MILITARY SPECIFICATION

CASE, CARRYING: 8213884

This amendment forms a part of Military Specification MIL-C-60126A(MU), dated 30 March 1966.

FIGURE 1A-CASE ASSEMBLY

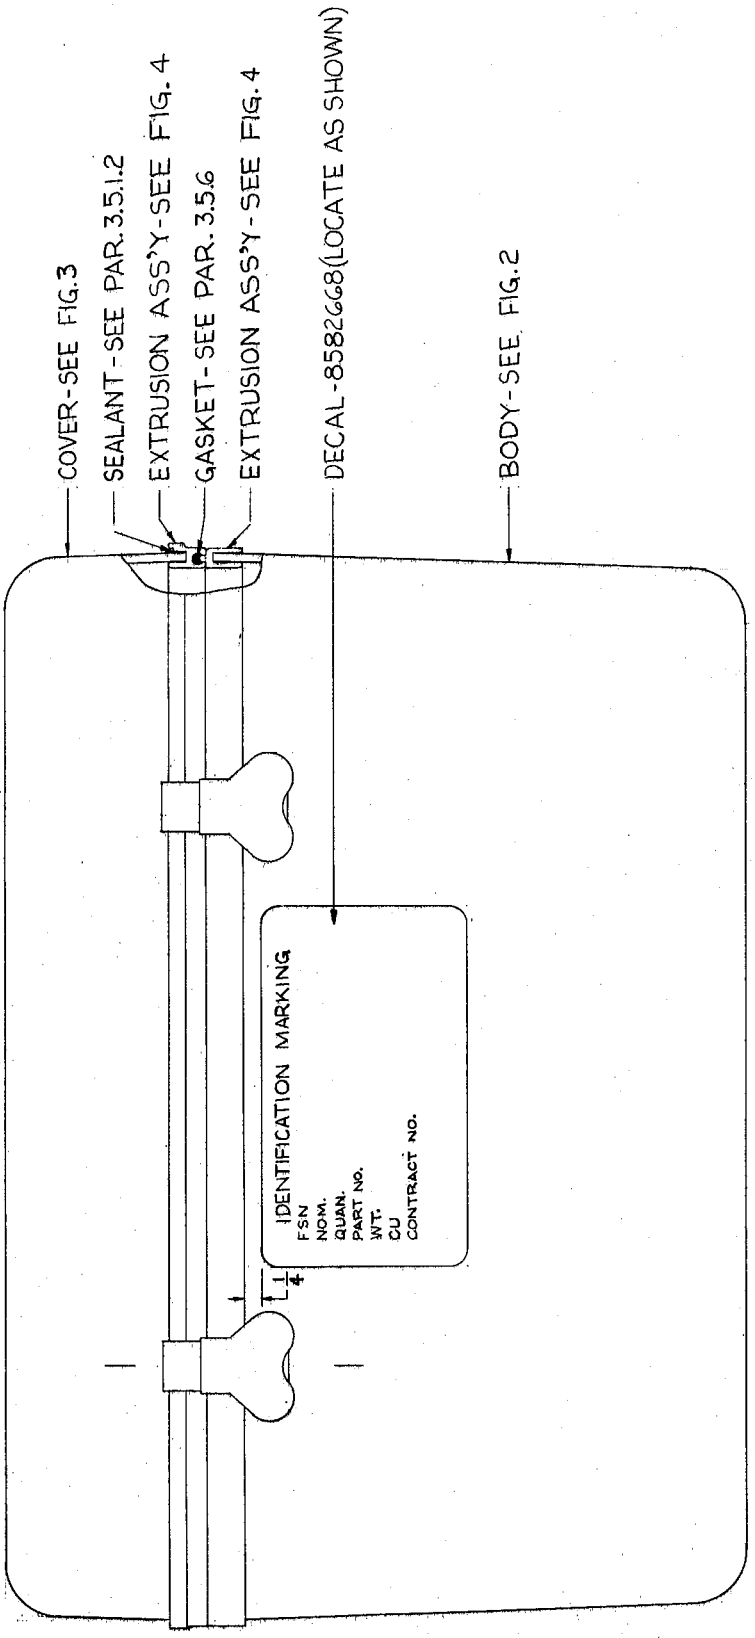
"3.5.6 Sealing gasket.- Gasket shall be fabricated of rubber .156 O.D. by .093 I.D. conforming to MIL-R-3065; Type S, Class SC, Grade No. SC415 A_1 B_1 F_2 K of MIL-STD-417. The gasket shall be formed by vulcanizing or butt bonding. Butt bonding shall be accomplished with adhesive conforming to MIL-A-5092, Type II. Prior to inserting the gasket in the female extrusion edge, adhesive conforming to MIL-A-5092, Type II shall be uniformly applied within the well. There shall be no evidence of excess adhesive in the gasket well. The exposed gasket shall be surface treated with a soft film silicone compound conforming to MIL-C-21567 (see Figure 1A)."

FIGURE 4-EXTRUSION ASSEMBLIES

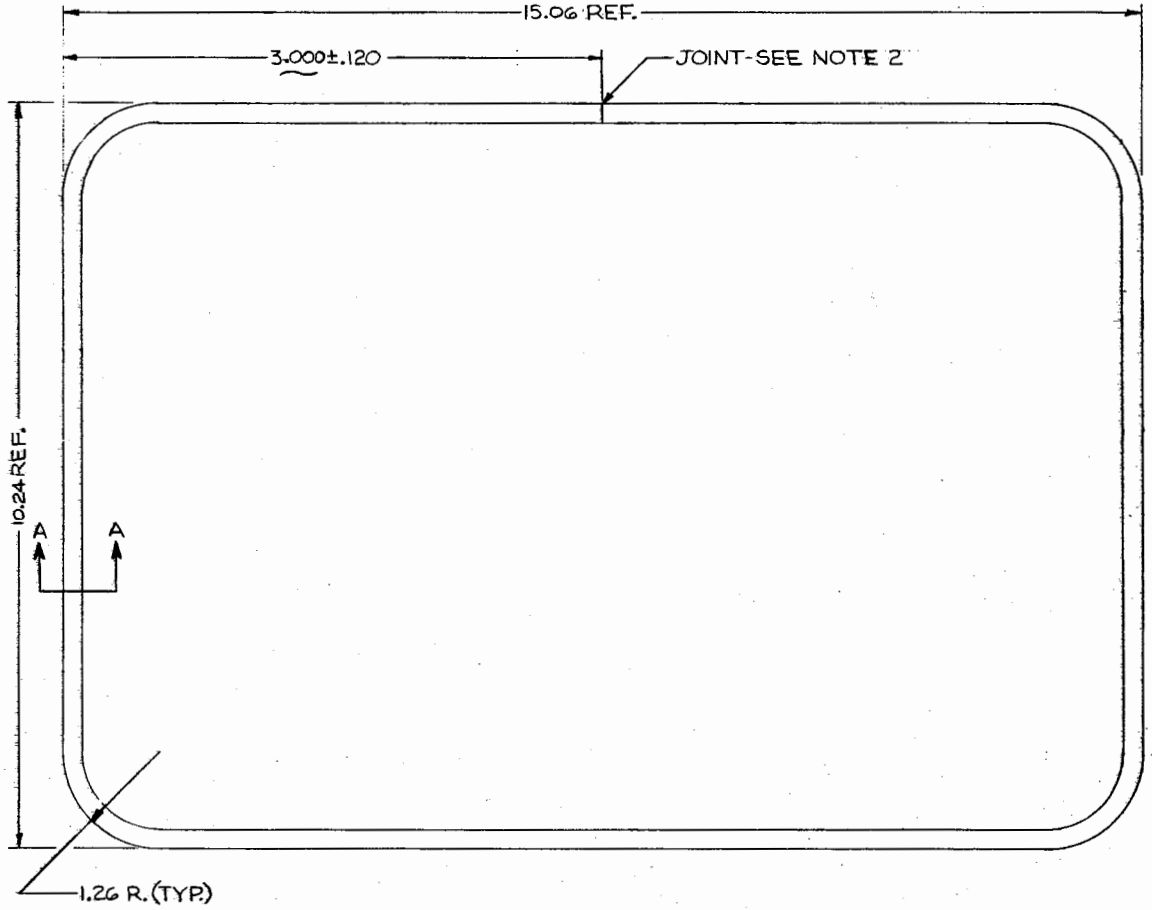
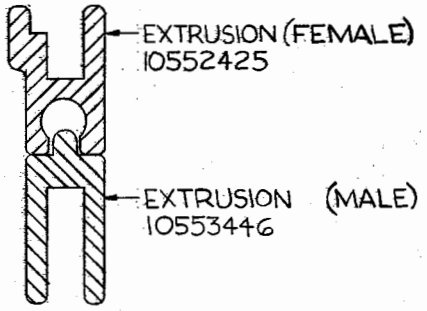
"3.5.1 Extrusion edge assemblies.- The upper extrusion edge (female) DrawingB10552425 and the lower extrusion edge (male) Drawing B10553446 shall be formed in one continuous operation by proven forming techniques and controlled tooling to provide uniformity of alignment, flatness and shall fit freely in each other when case is closed. The formed extrusions shall be free of chatter, tool marks and distortions. The extrusions shall be joined by butt welding or brazing and shall be ground smooth and exhibit soundness of good practices in accordance with MIL-W-8604 and MIL-B-23362."
